Louisville Metro Council City Agency Request

Capital Infrastructure Fund (CIF)

Amount: \$3,750	Date: 06/16/20	
Description of program/project including location of project/program and any extendance MAP MATCH	public purpose, additional grantee(s): 8115-410-8210-148937-89999	99 for \$292.35
Repaving of the alley at Coke Street and Sou	– th Clay Street to the dead e	end.
Total project cost \$7,500, and will be funded 4, Capital Infrastructure Fund \$3,750. Alley	•	53,750, and District
City Agency: Public Works		
Contact Person: Matt Haines		
Agency Phone: (502) 574-3883		
I have reviewed this request for an expend determined the funds will be used for a pul documentation from the receiving departm	blic purpose and have the	attached
4 Faleur Setton mix	3,750.00	6/16/20
District # Council Member Signature	3,750.00 Amount	
Approved by: Appropriations Committee Chaire Clerk's Office & OMB Use Only:	Amount	6/16/20
Approved by: Appropriations Committee Chaire Clerk's Office & OMB Use Only: Request Amount:	Amount	Date Date

NDF, CIF, MAP OR PAV INTERAGENCY CHECKLIST				
Interagency Name: Public Works				
Program/Project Name: Paving of Coke Street to				
	Yes/No/N	Yes/No/NA		
Request Form

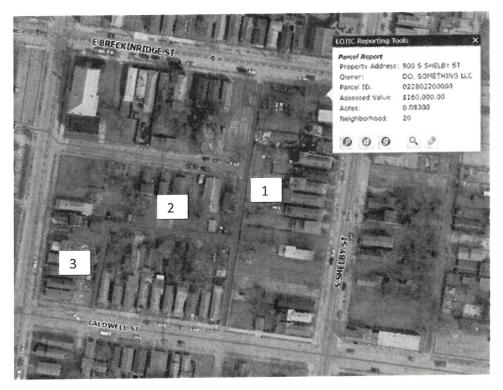
Looking into this request, there are 3 different legs of the alley as shown below.

- 1) The section that runs from Caldwell to Breckenridge is asphalt and in poor shape. Suggesting 2 inch mill and repave with fiber reinforced asphalt.
- 2) The section that runs parralell to East Caldwell just south of Coke St looks like asphalt. Also suggesting a 2 inch mill and overlay with fiber reinforced asphalt.
- 3) The section running north of Caldwell which terminates into section 2 appears to be a brick alley. Due to inflated costs to repair or replace bricks, suggesting noting occur here.

Based on the recommendations above, I am coming up with a cost of \$25,000.00 to repave the aspahalt sections of alley. This includes updates to 3 sidewalk ramps to become ADA Compliant.

I am going to strongly recommend that if this alley is repaved, the section of Coke St from S Clay to the dead end at this alley also be repaved. I estimate the paving of this street should cost an additional \$7,500.00.
